ACCESSIBILITY ASSESSMENT

July 13, 2021

ADA TITLE II ASSESSMENT

Rollingcrest Village
5631 Sargent Road
Hyattsville, Maryland 20782

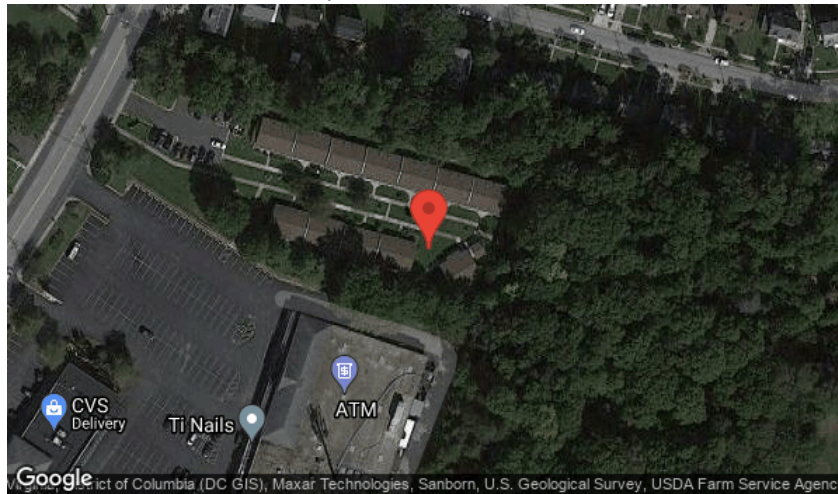
The accessible door with door closer has a sweep period of less than 5 seconds from 90 degrees to a position 12 degrees from latch and the opening force required to open the accessible, hinged, non-fire door is more than 5 pounds.

The door to the laundry room requires up to 15 pounds of force to operate and has a closing speed of up to 2.06 seconds from 90 degrees to a position 12 degrees from latch.

Adjust closer or remove and replace closer to ensure that the door has a closure time of at least 5 seconds within 12 degrees of the latch and that requires no more than 5 pounds of force for pushing or pulling the door open. Door closers and gate closers shall be adjusted so that from an open position of 90 degrees, the time required to move the door to a position of 12 degrees from the latch is 5 seconds minimum. The force at the latch, the force to set the door in motion, and the force to fully open the door shall be maximum 5 pounds. These forces do not apply to the force required to retract latch bolts or disengage other devices that hold the door or gate in a closed position.

Map for Barrier ID: AX239912

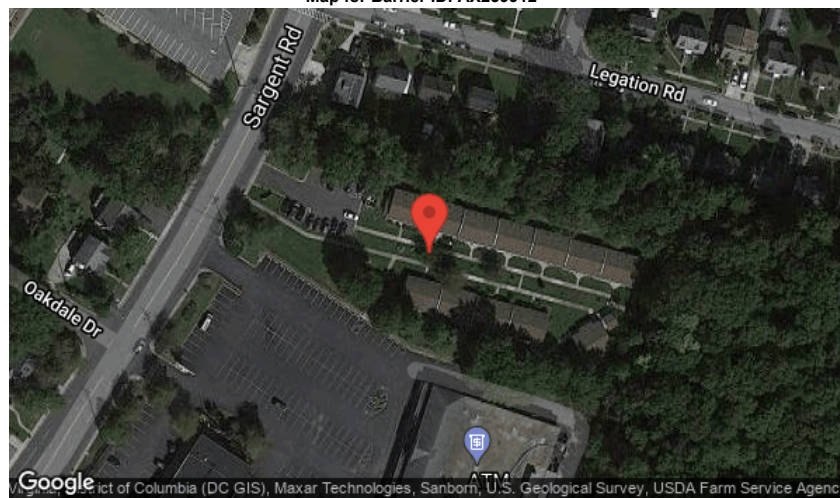
The accessible route has areas of vertical level changes in excess of 1/4" that are not beveled or ramped.

The accessible route has vertical changes of up to 3/4" with no bevel for an area of approximately 6 square feet.

The accessible route should be repaired to eliminate vertical level changes greater than 1/4". Changes in level of 1/4" high maximum shall be permitted to be vertical. Changes in level between 1/4" high minimum and 1/2" high maximum shall be beveled with a slope not steeper than 1:2. Changes in level greater than 1/2" shall be ramped.

Map for Barrier ID: AX239913

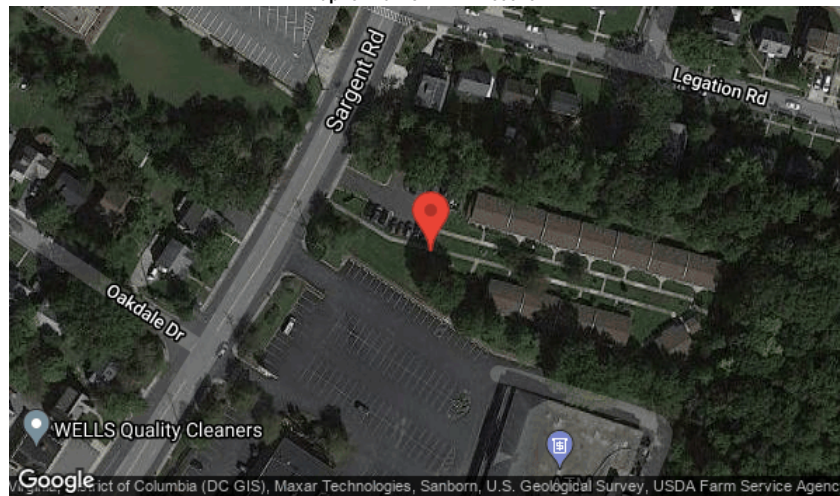
Assembly	Accessible Parking
Type	Parking Space-Car
ADA Standard	UFAS 4.6.3
Barrier Detail	The slope of the standard car access aisle is greater than 1:50 (2%).
Location Description	Parking Lot - P1
Observed	May 20, 2021 by Ouraccessibleworld@gmail.com

Remove and replace with an adjacent access aisle that is at least 60" wide and has a maximum slope of 1:50 (2%) in all directions. Parking spaces and access aisles shall be level with surface slopes not exceeding 1:50 in all directions. Parking access aisles shall be part of an accessible route to the building or facility entrance. Parked vehicle overhangs shall not reduce the clear width of an accessible circulation route. The quantity and order of magnitude cost estimate provided for this barrier are limited to the extent of the area identified as non-compliant. Additional costs that may be associated with removal of the barrier are not included.

Map for Barrier ID: AX239914

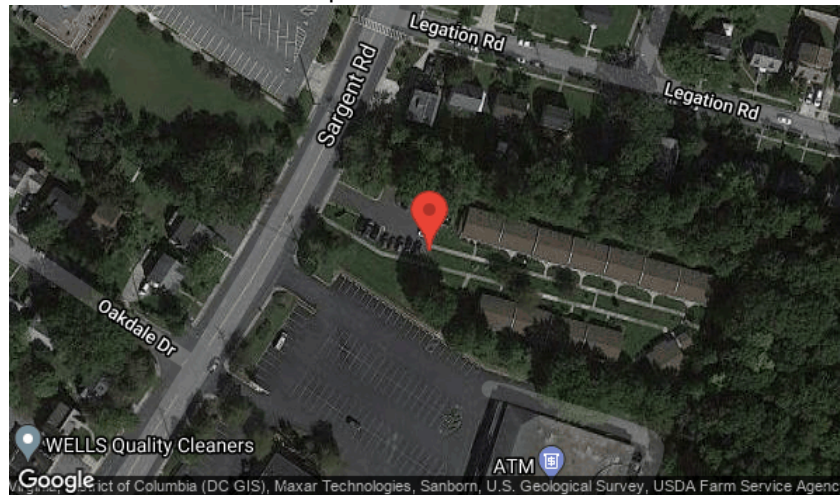
Assembly	Accessible Parking
Type	Parking Space-Car
ADA Standard	UFAS 4.6.3
Barrier Detail	The slope of the standard car parking space is greater than 1:50 (2%).
Location Description	Parking Lot - P1
Observed	May 20, 2021 by Ouraccessibleworld@gmail.com
Site Conditions	The parking space has a running and cross slope of up to 2.8%

Remove and replace with a parking space that has no more than 1:50 (2%) slope in all directions. Parking spaces for disabled people shall be at least 96" wide and shall have an adjacent access aisle 60" wide minimum (see Fig. 9). [EXCEPTION: If accessible parking spaces for vans are provided, each should have an adjacent access aisle at least 96" wide.] Parking access aisles shall be part of an accessible route to the building or facility entrance. Two accessible parking spaces may share a common access aisle. Parked vehicle overhangs shall not reduce the clear width of an accessible circulation route. Parking spaces and access aisles shall be level with surface slopes not exceeding 1:50 in all directions. The quantity and order of magnitude cost estimate provided for this barrier are limited to the extent of the area identified as non-compliant. Additional costs that may be associated with removal of the barrier are not included.

Map for Barrier ID: AX241408

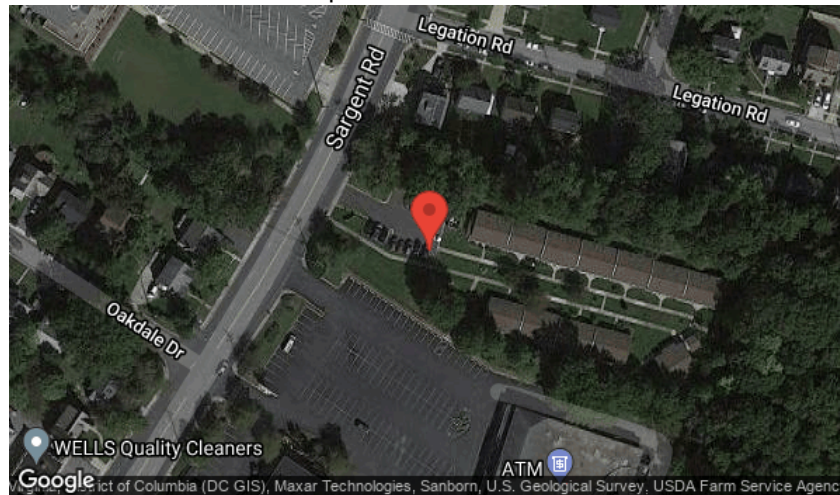
Assembly	Accessible Parking
Type	Parking Space-Car
ADA Standard	UFAS 4.6.3
Barrier Detail	The slope of the standard car parking space is greater than 1:50 (2%).
Location Description	Parking Lot A - Space P2-A
Observed	May 14, 2018 by siloyd
Site Conditions	The cross slope is 2.9% and the running slope is 3.3%.

Remove and replace with a parking space that has no more than 1:50 (2%) slope in all directions. Parking spaces for disabled people shall be at least 96" wide and shall have an adjacent access aisle 60" wide minimum (see Fig. 9). [EXCEPTION: If accessible parking spaces for vans are provided, each should have an adjacent access aisle at least 96" wide.] Parking access aisles shall be part of an accessible route to the building or facility entrance. Two accessible parking spaces may share a common access aisle. Parked vehicle overhangs shall not reduce the clear width of an accessible circulation route. Parking spaces and access aisles shall be level with surface slopes not exceeding 1:50 in all directions. The quantity and order of magnitude cost estimate provided for this barrier are limited to the extent of the area identified as non-compliant. Additional costs that may be associated with removal of the barrier are not included.

Map for Barrier ID: AX241409

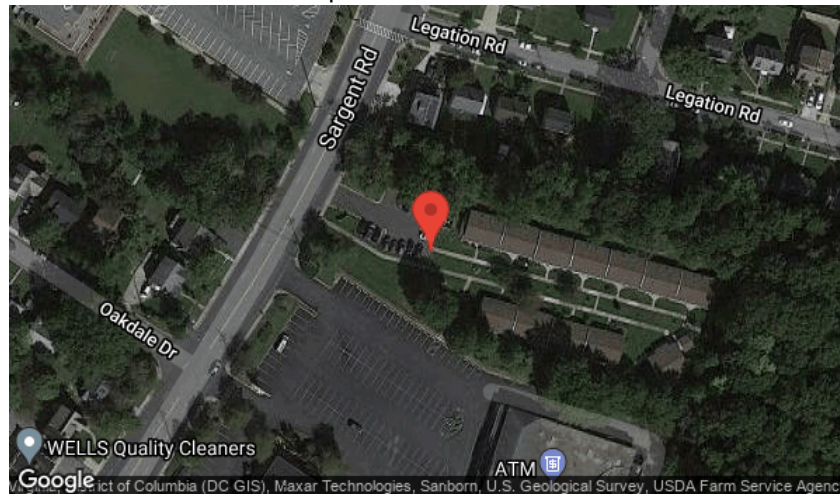
Assembly	Accessible Parking
Type	Parking Space-Car
ADA Standard	UFAS 4.6.3
Barrier Detail	The slope of the standard car access aisle is greater than 1:50 (2%).
Location Description	Parking Lot A - Space P2-A
Observed	May 14, 2018 by siloyd
Site Conditions	The cross slope is 8.2% and the running slope is 2.8%.

Remove and replace with an adjacent access aisle that is at least 60" wide and has a maximum slope of 1:50 (2%) in all directions. Parking spaces and access aisles shall be level with surface slopes not exceeding 1:50 in all directions. Parking access aisles shall be part of an accessible route to the building or facility entrance. Parked vehicle overhangs shall not reduce the clear width of an accessible circulation route. The quantity and order of magnitude cost estimate provided for this barrier are limited to the extent of the area identified as non-compliant. Additional costs that may be associated with removal of the barrier are not included.

Map for Barrier ID: AX241415

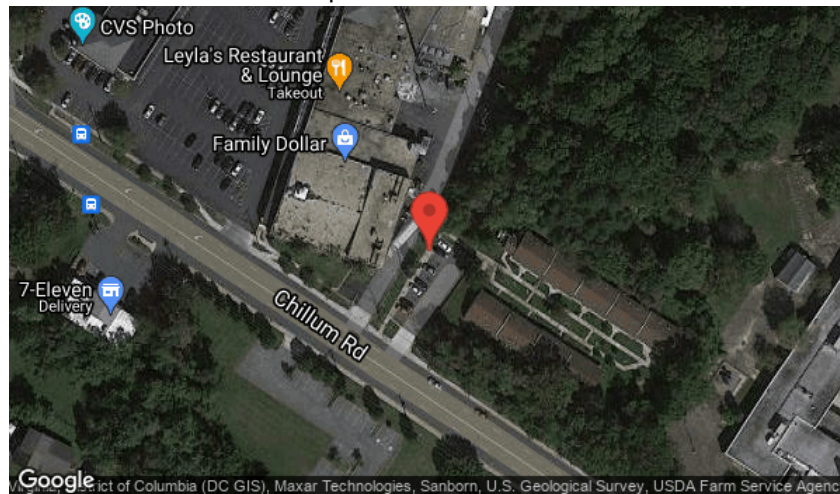
Barrier Detail

Provide a mounted sign stating "No Parking in Access Aisle" at the van access aisle. This barrier must be removed in conjunction with barrier ID 109263. Signs shall be 84" minimum above the finish floor or ground surface measured to the bottom of the sign OR if flush to/mounted on building or wall, sign should be mounted between 72" and 120" above grade. Where the sign post is mounted on a raised surface which is higher than the stall pavement, the vertical measurement shall be from the stall pavement surface to the bottom of the sign.

Map for Barrier ID: AX241413

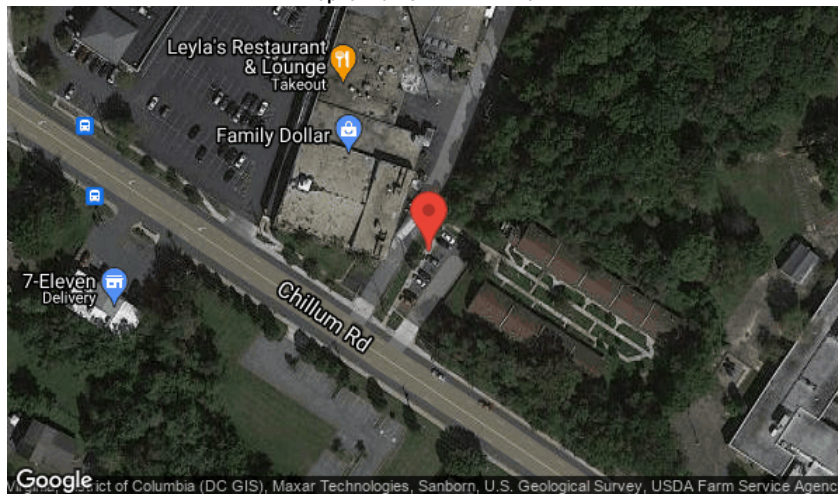
Assembly	Accessible Parking
Type	Parking Space-Van
ADA Standard	State of MD 05.07.D (2)(a)and (b),(3) & (6)
Barrier Detail	MARYLAND: Compliant signage is not provided at the space.
Location Description	Parking Lot B - Spaces P1-B
Observed	May 8, 2018 by ouraccessibleworld

Provide a mounted sign for a van accessible stall which is not obscured by a vehicle parked in the space. Parking space identification signs shall include the International Symbol of Accessibility. Signs identifying van parking spaces shall contain the designation "van accessible," "Reserved Parking", and "Maximum Fine \$XXX". Accessible parking fine amounts vary per county in the State of Maryland. Signs shall be 84" minimum above the finish floor or ground surface measured to the bottom of the sign OR if flush to/mounted on building or wall, sign should be mounted between 72" and 120" above grade.

Map for Barrier ID: AX239895

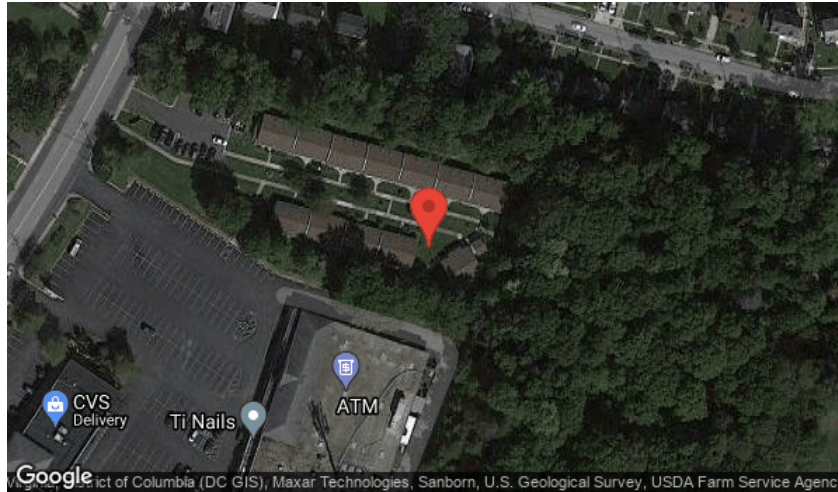
Barrier Detail

Remove and lower to a compliant reach range. Where a forward reach is unobstructed, the high forward reach shall be 48" maximum and the low forward reach shall be 15" minimum above the finish floor or ground. the element for a distance not less than the required reach depth over the obstruction. The high forward reach shall be 48" maximum where the reach depth is 20" maximum. Where the reach depth exceeds 20", the high forward reach shall be 44" maximum and the reach depth shall be 25" maximum. Where a clear floor or ground space allows a parallel approach to an element and the side reach is unobstructed, the high side reach shall be 48" maximum and the low side reach shall be 15" minimum above the finish floor or ground. [EXCEPTION: 1. An obstruction shall be permitted between the clear floor or ground space and the element where the depth of the obstruction is 10" maximum.] Where a clear floor or ground space allows a parallel approach to an element and the high side reach is over an obstruction, the height of the obstruction shall be 34" maximum and the depth of the obstruction shall be 24" maximum. The high side reach shall be 48" maximum for a reach depth of 10" maximum. Where the reach depth exceeds 10", the high side reach shall be 46" maximum for a reach depth of 24" maximum.

Photos for Barrier ID: AX239903

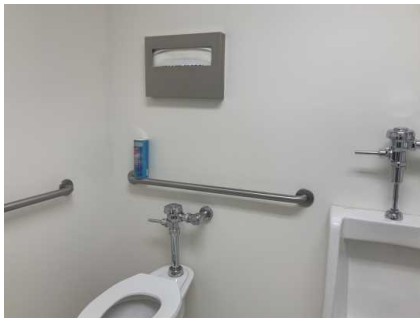
Assembly	Restroom
Type	Controls And Dispensers
ADA Standard	606.1; 309.3
Barrier Detail	The height of controls are not compliant.
Location Description	Office Restroom
Observed	May 20, 2021 by Ouraccessibleworld@gmail.com
Site Conditions	The seat cover dispenser is mounted at 58" above the floor.

Provide operable parts of all controls, dispenser, receptacle and other operable equipment within at least one of the reach ranges. Operable parts shall be placed within one or more of the reach ranges. Unobstructed Forward Reach: Where a forward reach is unobstructed, the high forward reach shall be 48" maximum and the low forward reach shall be 15" minimum above the finish floor or ground. Obstructed High Forward Reach: Where a high forward reach is over an obstruction, the clear floor space shall extend beneath the element for a distance not less than the required reach depth over the obstruction. The high forward reach shall be 48" maximum where the reach depth is 20" maximum. Where the reach depth exceeds 20", the high forward reach shall be 44" maximum and the reach depth shall be 25" maximum. Unobstructed Side Reach: Where a clear floor or ground space allows a parallel approach to an element and the side reach is unobstructed, the high side reach shall be 48" maximum and the low side reach shall be 15" minimum above the finish floor or ground. [EXCEPTION: An obstruction shall be permitted between the clear floor or ground space and the element where the depth of the obstruction is 10" maximum.] Obstructed High Side Reach: Where a clear floor or ground space allows a parallel approach to an element and the high side reach is over an obstruction, the height of the obstruction shall be 34" maximum and the depth of the obstruction shall be 24" maximum. The high side reach shall be 48" maximum for a reach depth of 10" maximum. Where the reach depth exceeds 10", the high side reach shall be 46" maximum for a reach depth of 24" maximum. [ADVISORY for Children's Forward or Side Reach Ranges: High reach (maximum): 36" for ages 3 to 4; 40" for ages 5 to 8; and 44" for ages 9 to 12. Low reach (minimum): 20" for ages 3 to 4; 18" for ages 5 to 8; and 16" for ages 9 to 12.]
